**Bid 643**  
**New HVAC Modernization Project for Rio Mesa High School**

**BID CLARIFICATION ADDENDUM #1**

Dated: December 30, 2020

- 3) Please refer to **Attachment B** for Architect's addendum 1

Job No: 2847.0200  
Date: 10/23/2020  
**M-601**

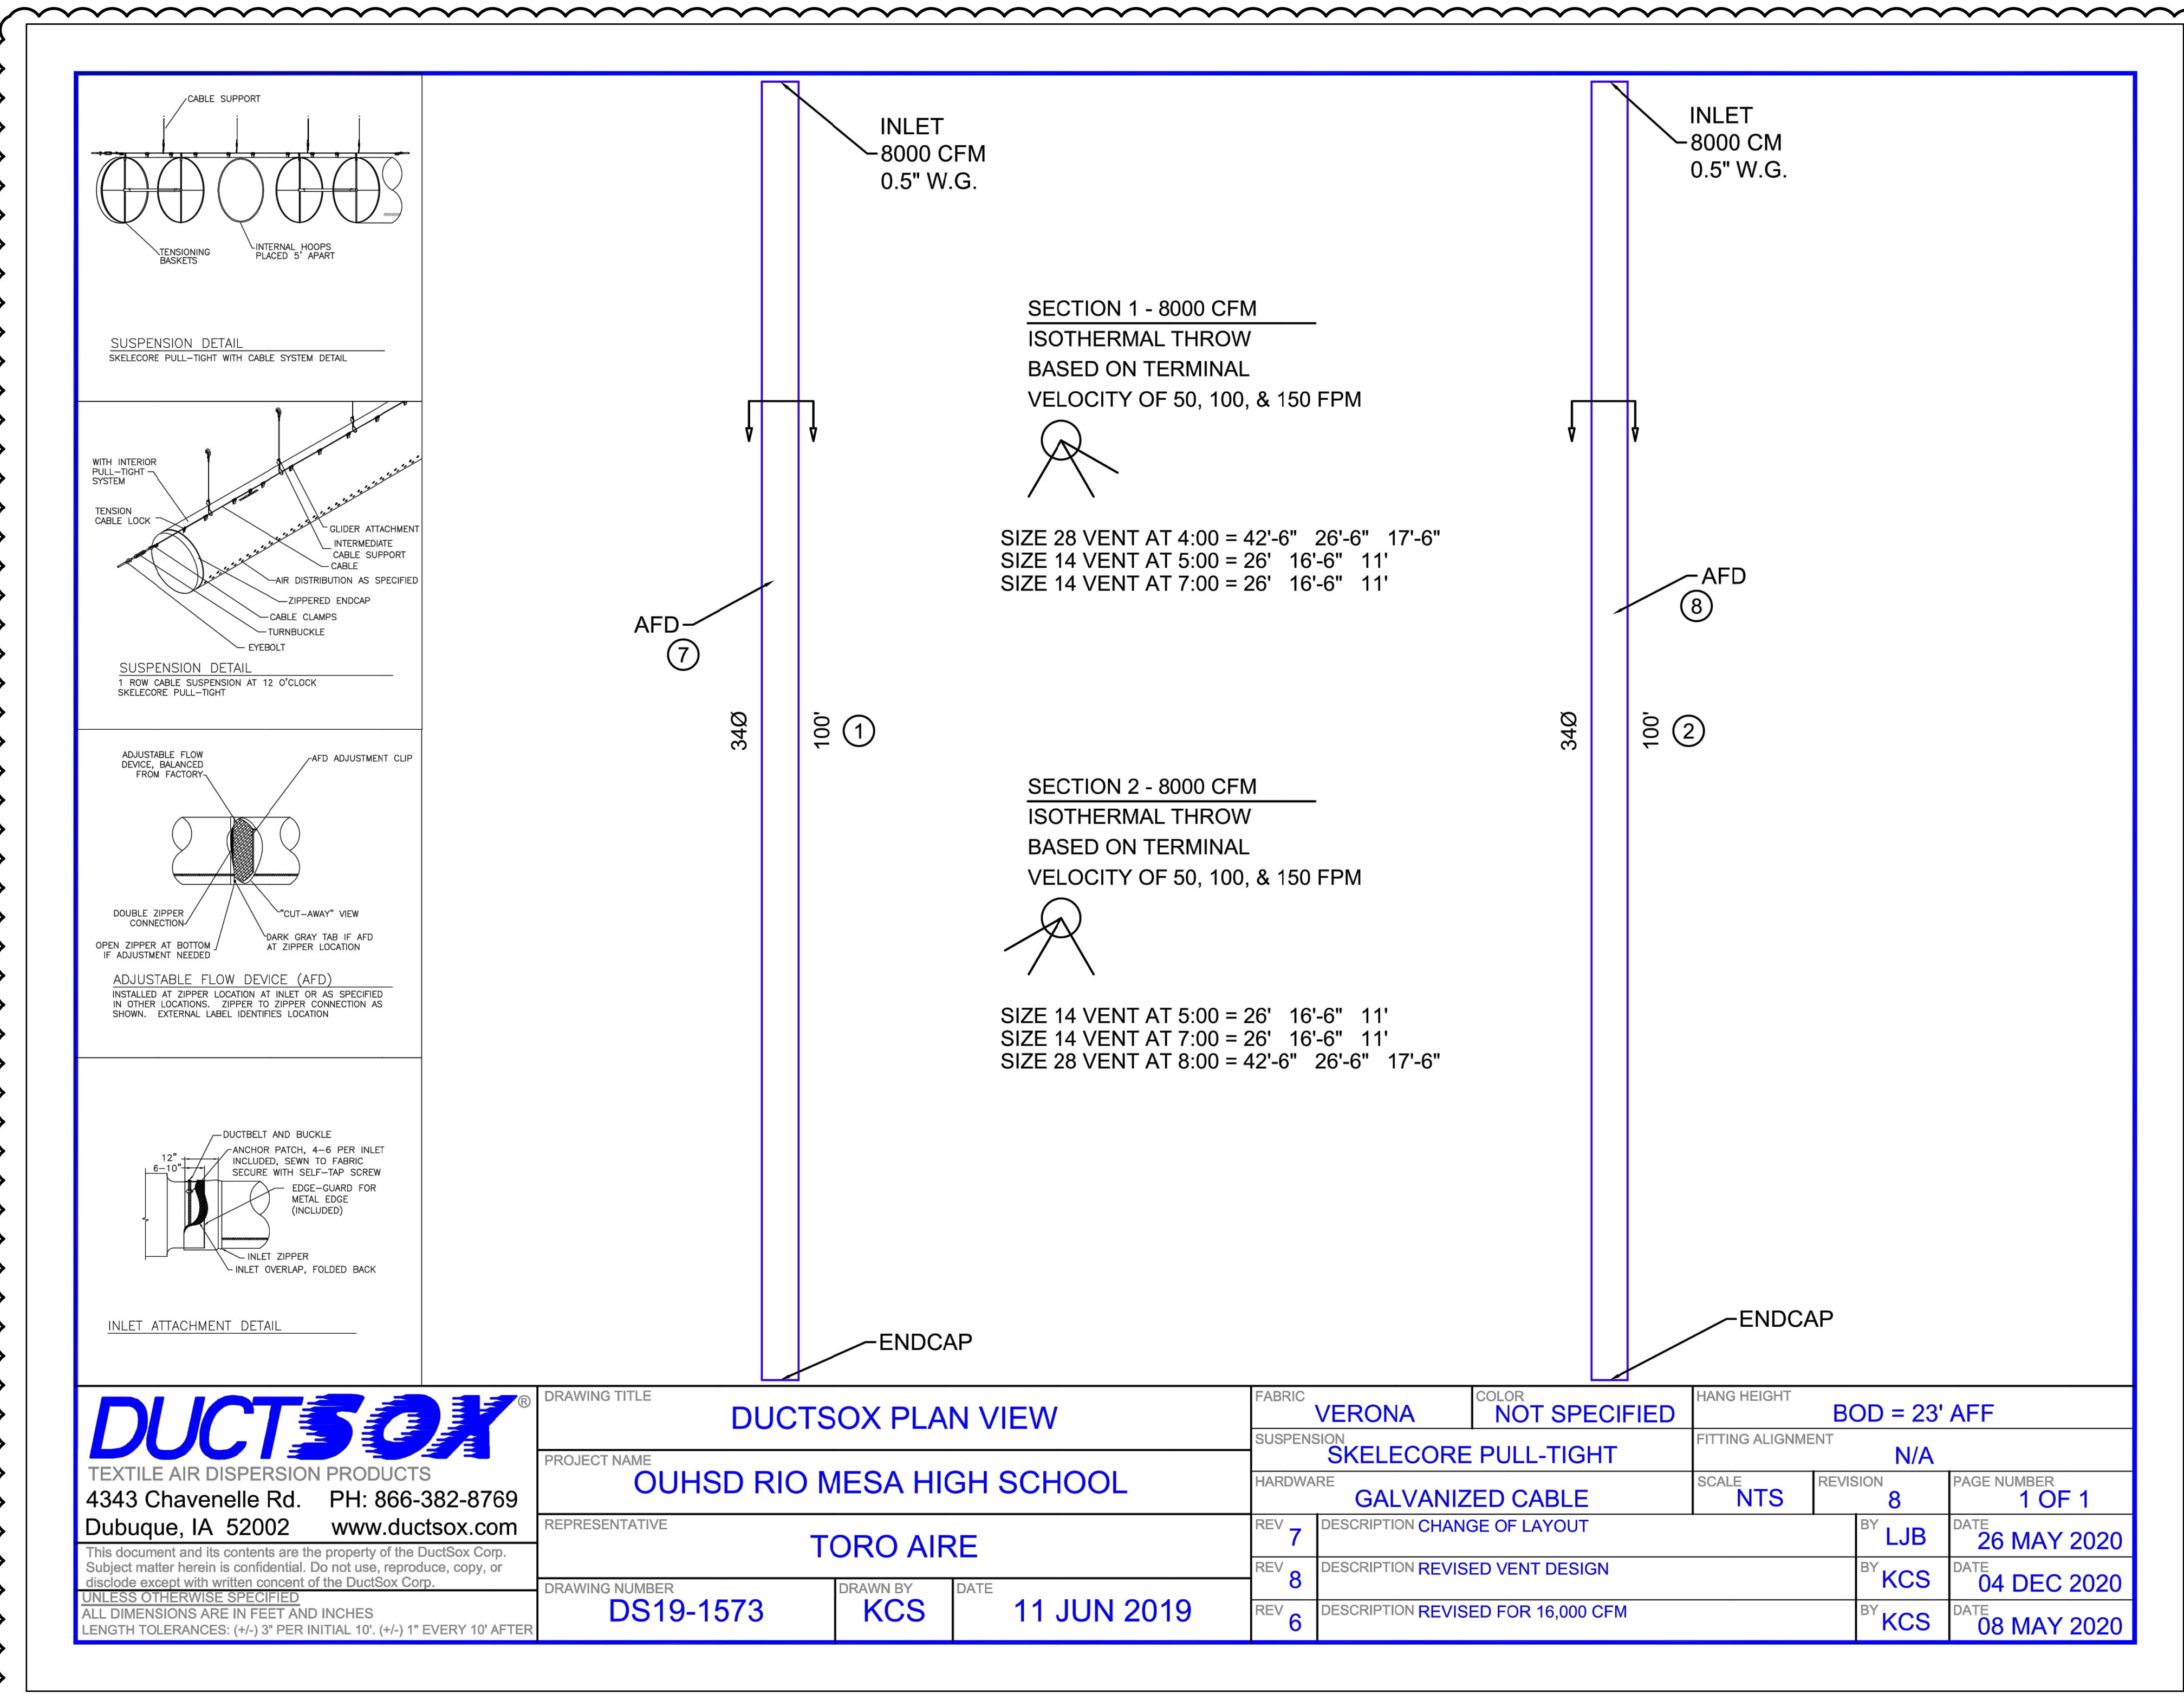
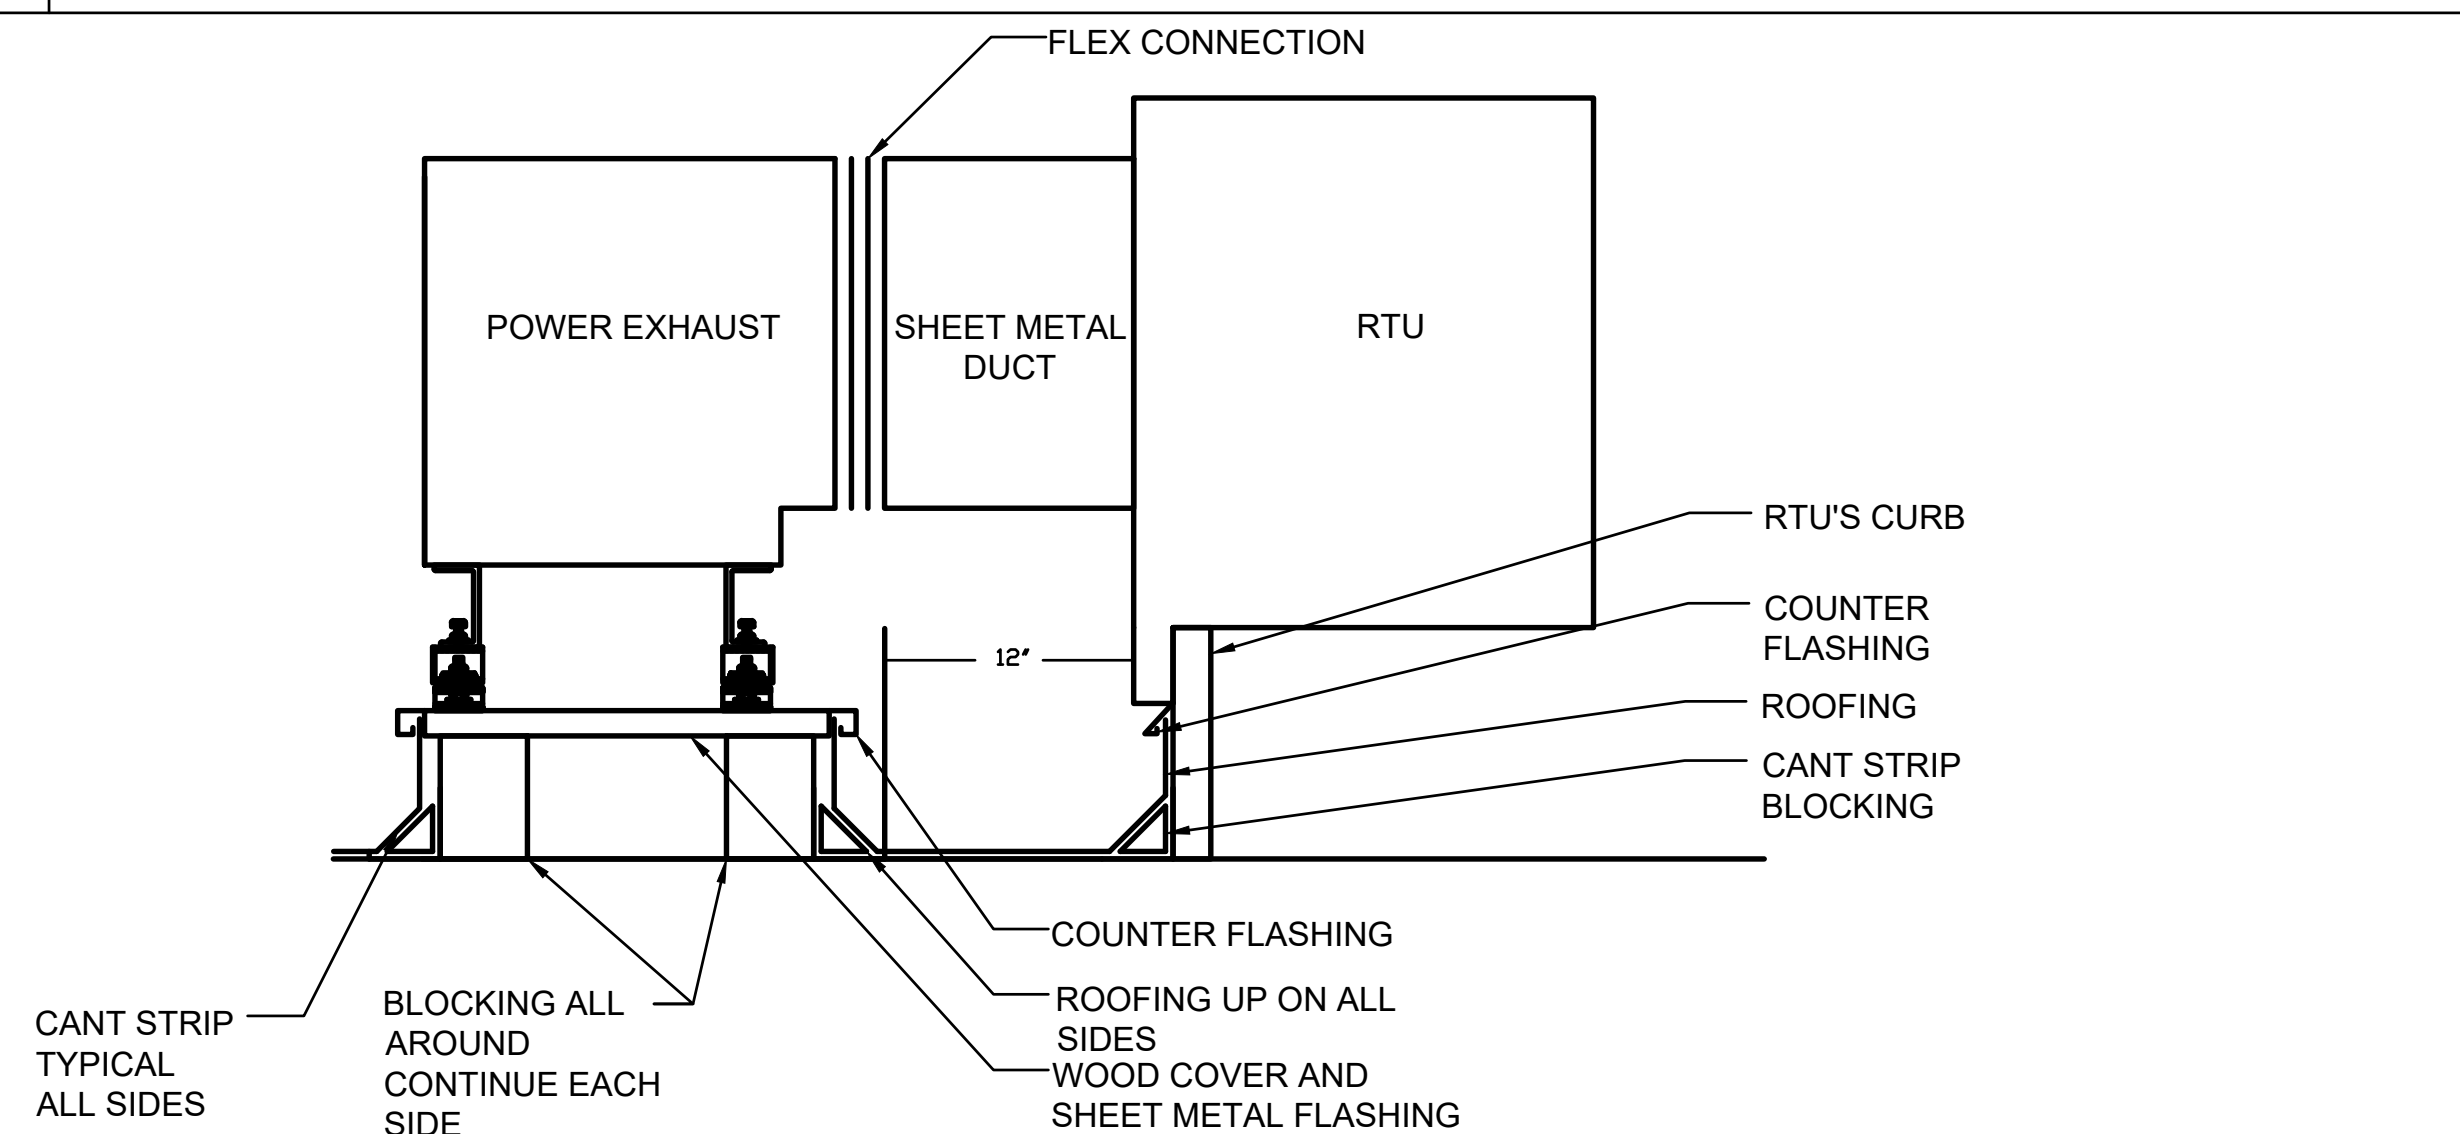
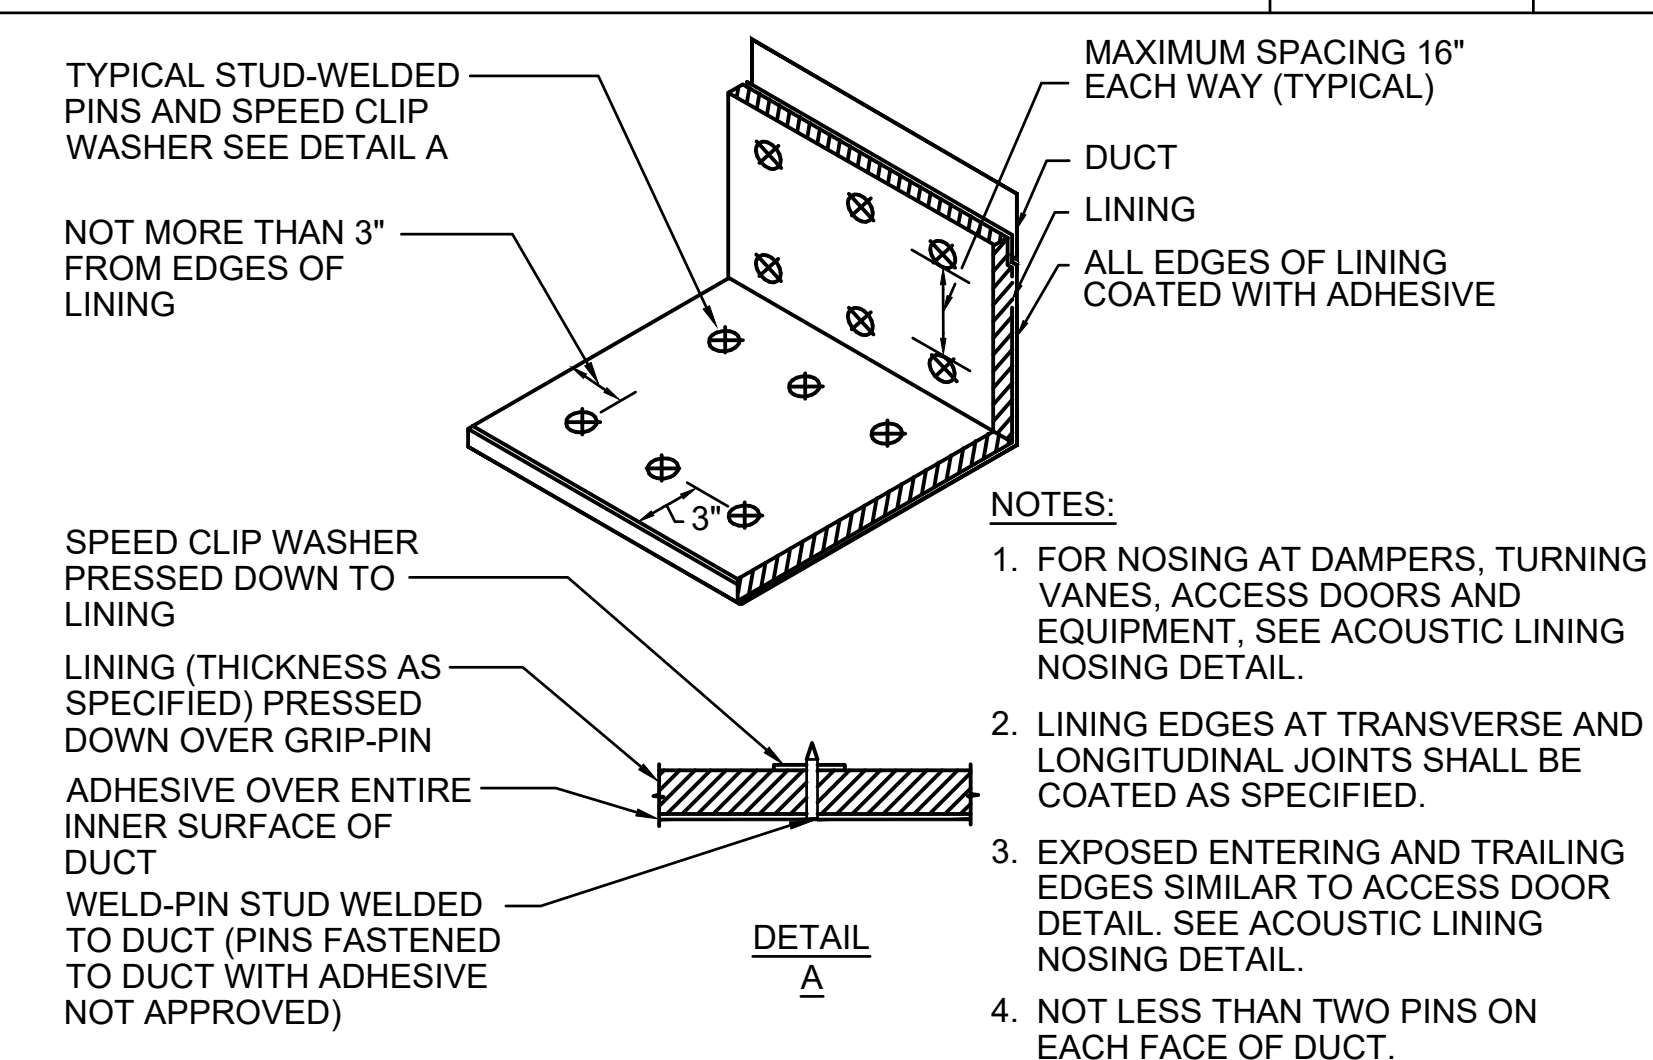
9. **Sheet SQ-202**
- a. **Replace** sheet SQ-202 in its entirety with Addendum No. 1 SQ-202.
10. **Sheet M-601**
- a. **Replace** detail 1/M-601 in its entirety with Addendum No. 1 detail 1/M-601.
